ORINATION FORM

Proposed Revisions to a Standard Plans Index

Index Number: 102-660

Index Title: Sidewalk Closure

PEDESTRIAN DIVERSION - OPTION 2
(Work Zone Speed 35 mph or Less)

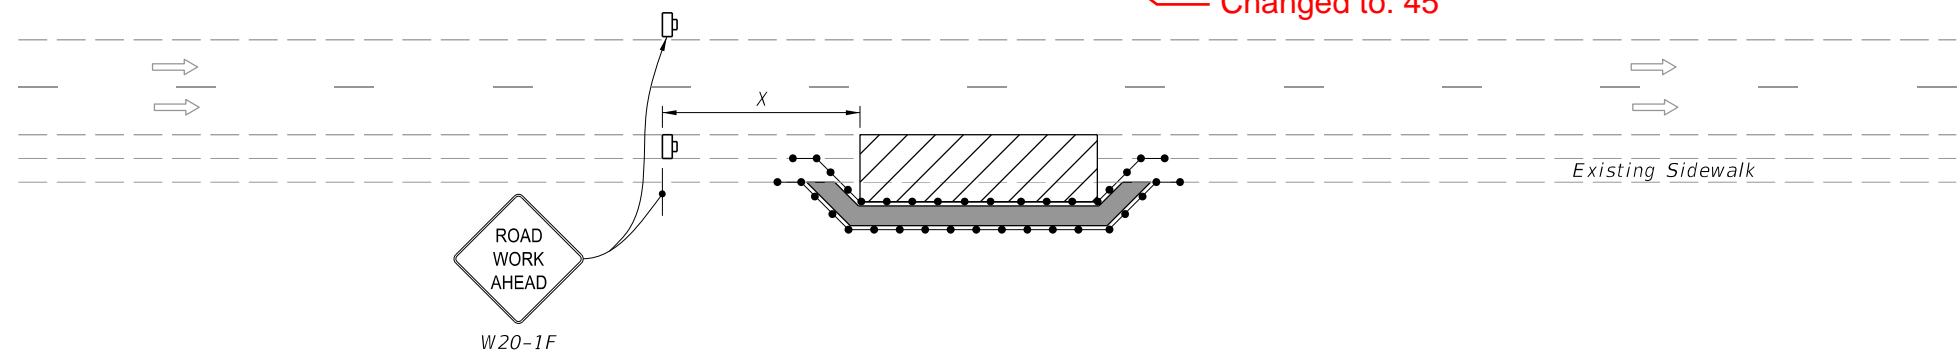
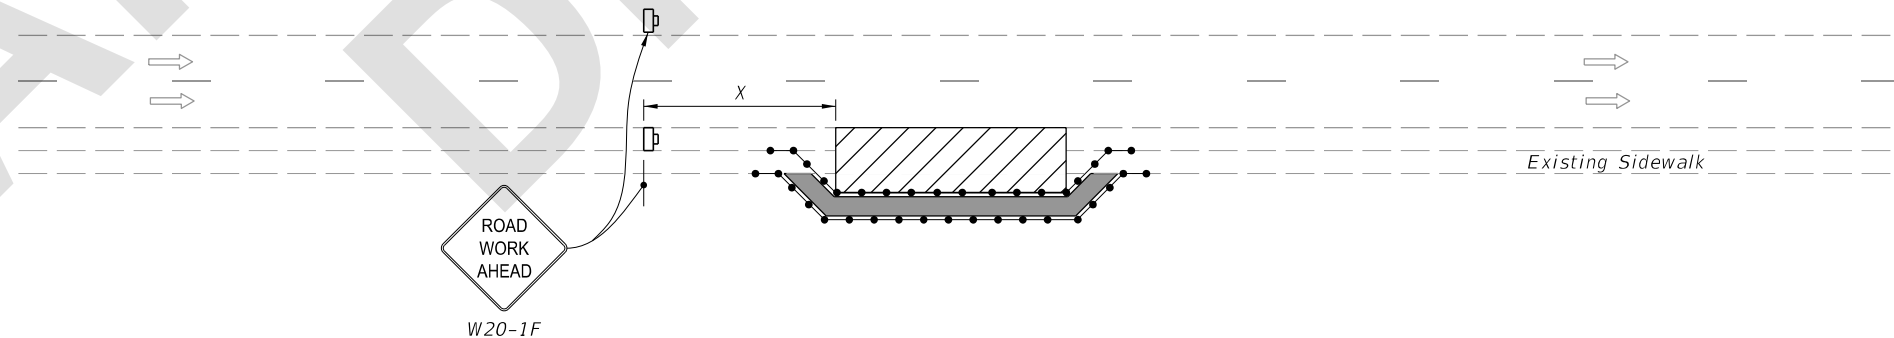
Increase the maximum work zone speed allowed for option 2 to 45mph.

With the work zone speed capped at 35mph, it creates a gap in the applicability of option 2. There have been work zones that needed to use option 2 because they could not meet the length of need requirements for option 1 but the speed limit was greater than 35mph. This makes using a lane closure for pedestrian accommodations difficult in these areas.

Changed to: 45

PEDESTRIAN DIVERSION - OPTION 2
(Work Zone Speed 45 mph or Less)
